MEMORANDUM

To: The Design Advisory Board
From: Mary O'Neil, AICP, Senior Planner
RE: ZP15-0810SP; 10 University Place
Date: March 10, 2015

Request: Sketch plan review for UVM undergraduate student housing on Central Campus.

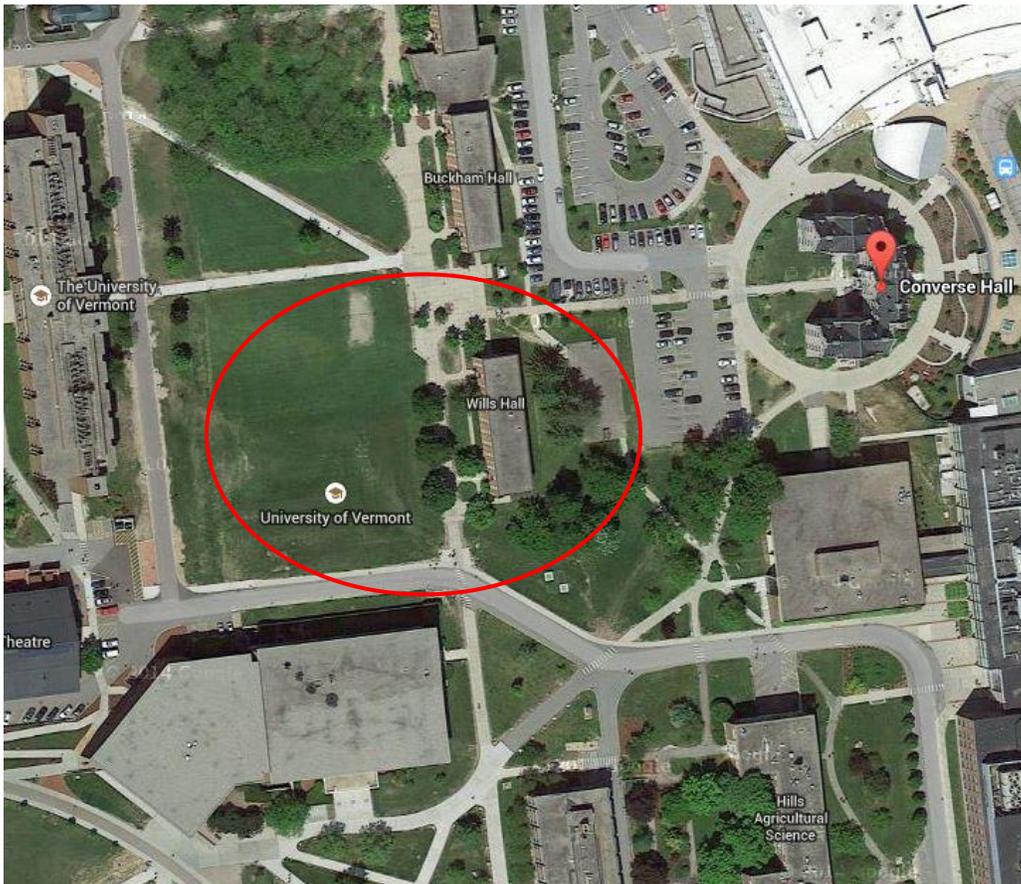
The proposed new dormitories are positioned in the southeast corner of the quad, just north of Bailey-Howe Library. Terminus views of Converse Hall, which is listed on the Vermont State Register of Historic Resources, are interrupted from westerly and southwesterly approaches to the green by the proposed building bulk. The new University of Vermont Medical Center Inpatient Building was adjusted to preserve these views to Converse; it would be consistent that new development would continue to protect terminus views of Converse Hall across the UVM quadrangle.

After removal of CBW, this will be an open area. While the site itself will no longer have structures, the proposed new dormitories will block the viewscape east to Converse Hall. The University of Vermont Inpatient Building was adjusted to the north to protect this terminus view from the UVM campus, recognizing the spatial importance of siting a new building; minimizing its impact on existing historically sensitive resources. The proposed location of the new buildings interrupts the east/west terminus views of Converse Hall.

The arrangement of the buildings appears to maximize southerly exposure which will have a direct benefit for solar gain. A green roof is proposed on the westerly building which will have environmental and stormwater benefits, if installed.
